Serial Number : 10/606695

Amendment in Response to Office Action of 09/07/2004

<u>REMARKS</u>

FIG 3

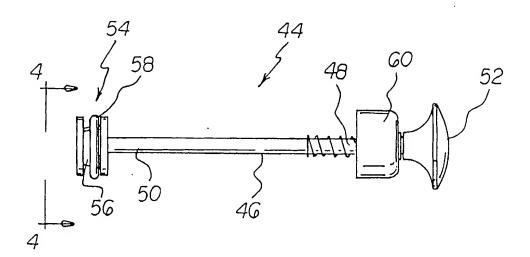
The Examiner's objections with regard to Figure 4 and the specification, Page 14, are noted. Submitted herewith is a replacement sheet showing Figures 3 and 4 which has been labeled "Replacement Sheet". Also submitted is a copy of the prior sheet showing of Figures 3 and 4 with the changes shown in red. In addition, the specification at the third paragraph of Page 14 beginning at Line 16 is amended to add the following language: "The pump subassembly has a circular end with an aperture 51 for the flow of air during the reciprocation of the handle while pumping. Such is well known in the pump art." It is deemed that the amendment to the specification and drawings submitted herewith overcome these objections.
